SUBMITTAL SUMMARY REPORT

MajorSite-000600-2026

PLAN NAME:	Exalt Health Summerfield	LOCATION:	
APPLICATION DATE:	04/09/2026	PARCEL:	47696-000-00
DESCRIPTION:	The project will consist of the construction of a 40-bed inpatient rehab hospital, along with associated utilities, stormwater and parking infrastructure.

MAJOR SITE PLAN
FOR
EXALT HEALTH SUMMERFIELD

Logan R Reiber, P.E.
FLORIDA LICENSE NUMBER: 248577001
DATE: JUNE 2026
PROJECT NO: 248577001
SHEET NUMBER: C-00
DATE: 6/9/2026

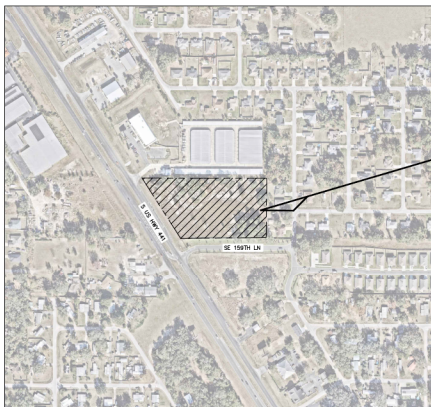
<i>Corrections</i>	2.12.4/6.11.8 - Parking (Not Resolved) - [6/18/26;] Staff accepts provided County parking standards to be used for the in-patient rehabilitation HOSPITAL. Please see mark-up on cover sheet. Please note that facility may NOT actually be used for housing for handicapped, elderly, ACLF, nursing homes, or similar uses. Please note that upon time that proposed hospital transitions into different use, including but not limited to uses such as long-term rehabilitation/assisted living facilities, a Special Use Permit must be applied for and approved by Board of County Commissioners. Please acknowledge. [INITIAL] Please indicate land use code for cited ITE Park Generation Manual figures			
<i>Corrections</i>	2.12.4.L & Article 5 - Overlay zones (Resolved) - [INFO] (1) FEMA Flood Zone X; (2) No ESOZ; (3) Secondary Springs Protection Zone			
<i>Corrections</i>	4.4 - Show proposed signs to meet LDC Sec 4.4 (Resolved) - [6/18/26] Single monument sign provided along NW corner of site. [INITIAL] Are any signs proposed? If so, please indicate on site plan. Please note that signs will require separate sign permit.

Please Note that hand-drawn markings are based on current parking PROPOSED.
